2006 Cadillac STS-V: Service Bulletin: #07-07-30-031D: Malfunction Indicator Lamp (MIL) On - Check Engine Light, DTC P0751

#07-07-30-031D: Malfunction Indicator Lamp (MIL) On - Check Engine Light, DTC P0751 (Diagnose and Repair as Necessary) - (Feb 20, 2009)

This bulletin is being revised to provide additional information on the new spacer plate. Please discard Corporate Bulletin Number 07-07-30-031C (Section 07 — Transmission/Transaxle).

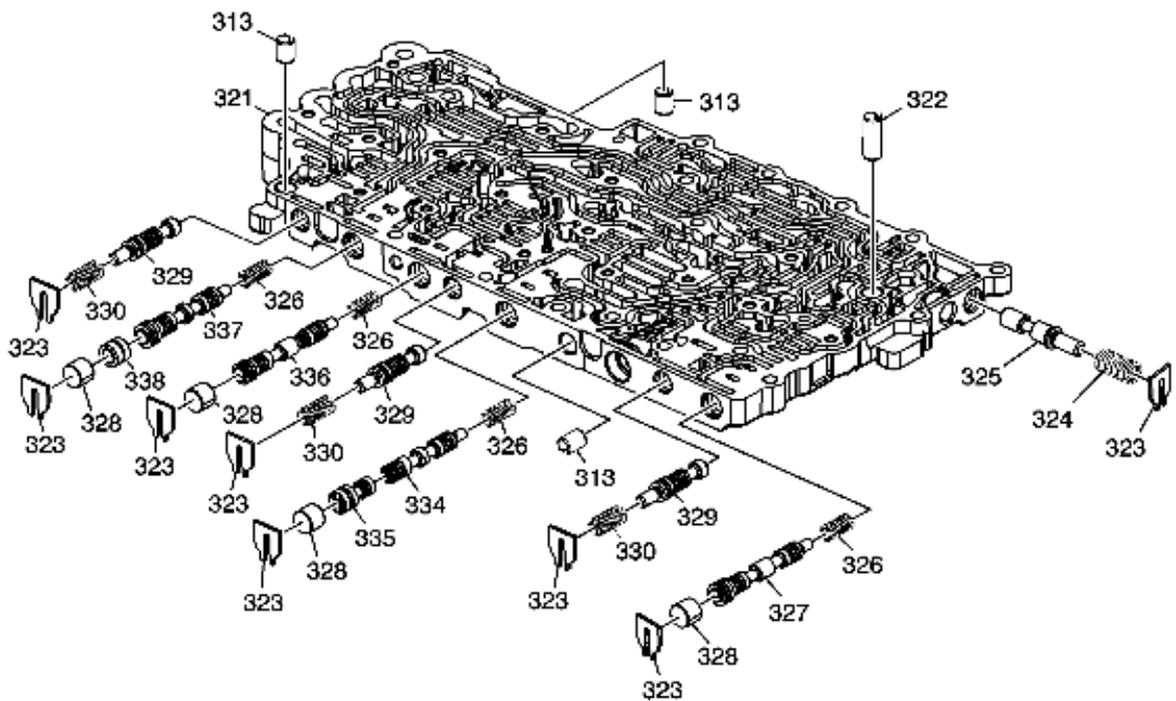
Some customers may comment on a malfunction indicator lamp (MIL) being illuminated.

A scan tool may reveal DTC P0751 set in the TCM as current or in history.

Correction

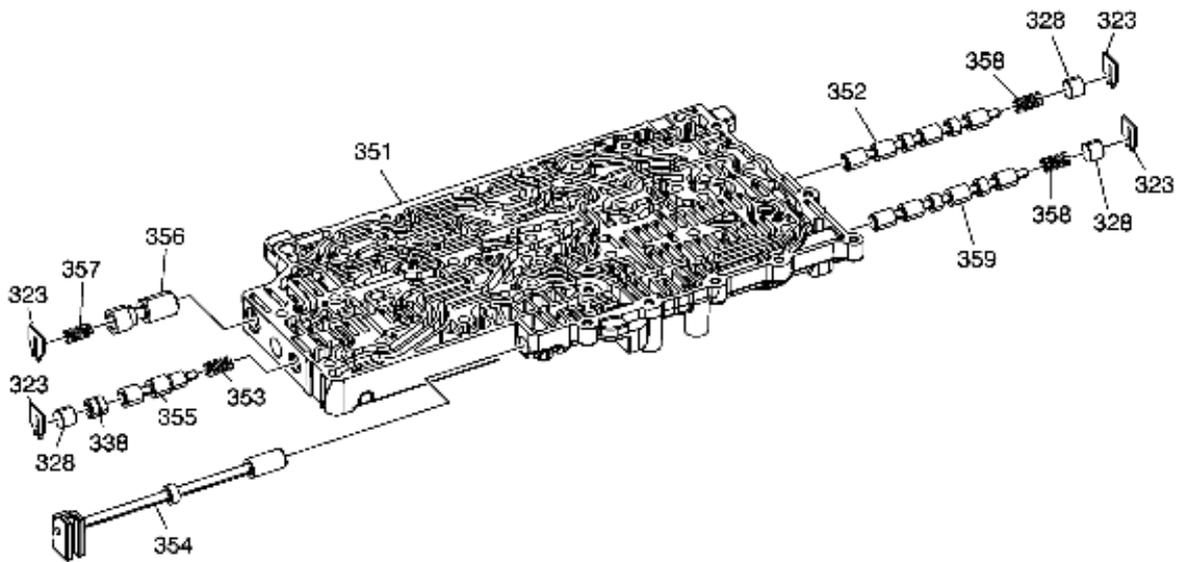
Follow the service instructions below based on the group your vehicle is in.

- Replace the spacer plate with P/N 24245720. This spacer plate makes use of a revised gasket to help reduce the occurrence of DTC P0751.

- Replace the spacer plate with the appropriate part number from the list below. This spacer plate makes use of a revised gasket to help reduce the occurrence of DTC P0751. *This spacer plate is used in vehicles built November 17, 2007 or later. It will not resolve a DTC P0751 concern on a vehicle built November 17,*
